United States  
Coast Guard

This letter serves to document the Coast Guard's Preliminary Navigation Clearance Determination (PNCD) for the Sound Transit (ST) Ballard light rail bridge project over Lake Washington Ship Canal (LWSC) near Ballard, WA. At the request of the Coast Guard, ST prepared a Navigation Impact Report (NIR) and delivered it to the Coast Guard in May of 2021. The Coast Guard reviewed your NIR and published a Navigation Public Notice to seek comments from maritime stakeholders. The Navigation Public Notice comment period ended on October 15, 2021, and the Coast Guard received approximately 50 comments. Both the NIR and public comments informed our PNCD.

### **Summary Conclusion for Preliminary Navigation Clearance Requirements**

Figure 11 Reduced Turning Radius between Fishermen's Terminal and the Ship Canal Navigation Channel

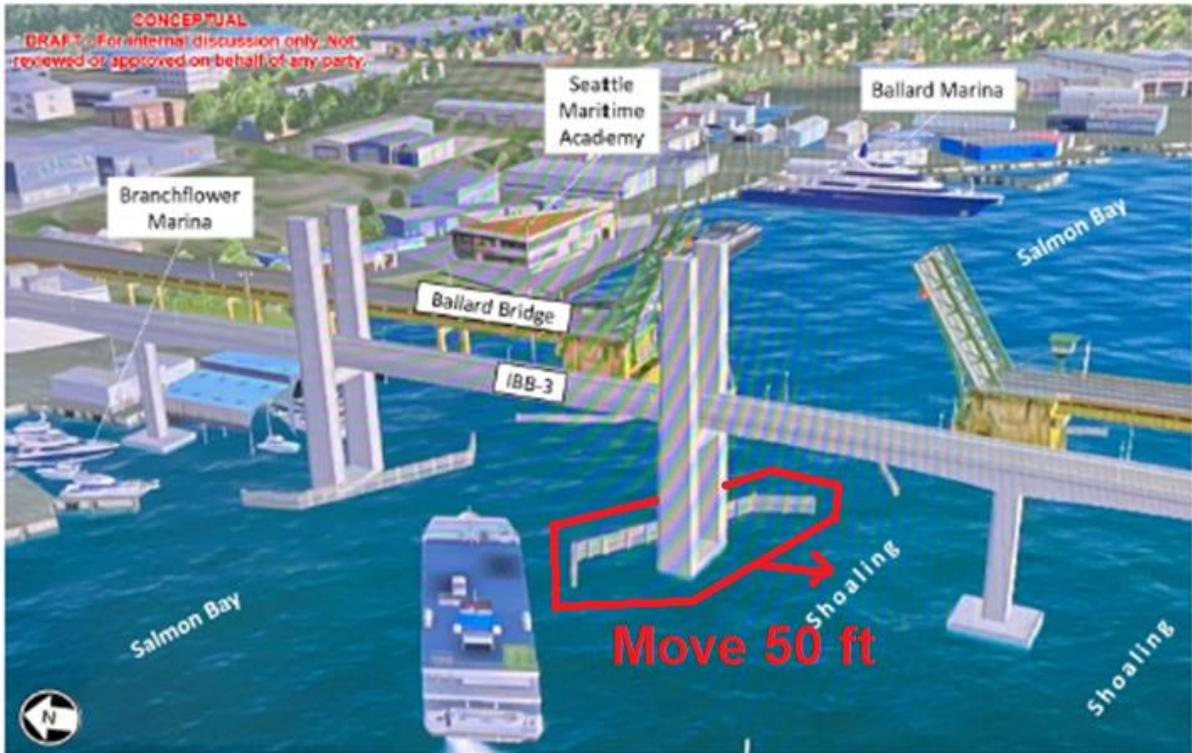
*Feedback during the navigation simulations indicated that the IBB-3 pier placement would also block critical lines of sight for both eastbound and westbound vessels, as well as constrain outbound and inbound access between the navigation channel and Fishermen’s Terminal. For example, several vessels in the simulations were not able to turn directly from the navigation channel into Fishermen’s Terminal or vice-versa because IBB-3 reduced the area available to merge into the navigation channel and created tight turns into and out of Fishermen’s Terminal. These vessels had to travel out of-direction and turn around to sail toward their destination. This impact could affect vessels accessing all of the Fishermen’s*

*Terminal facilities. Figure 11 shows an example of a tight turn out of Fishermen's Terminal and eastbound into the navigation channel (See NIR, Page 66 and Enclosure 3).*

- a. ST alternative IBB-3, west of the current Ballard Bridge, proposed a HNC of 150 feet. The Coast Guard would require a minimum of 200 feet of HNC for this alternative, and the pier faces should be north and south of the current main channel bridge faces, normal to the axis of the channel, which is skewed approximately 20 degrees.
- b. ST alternative IBB-1a, which is east of the current Ballard Bridge, proposed a HNC of 290 feet. This would provide adequate HNC at the waterline.
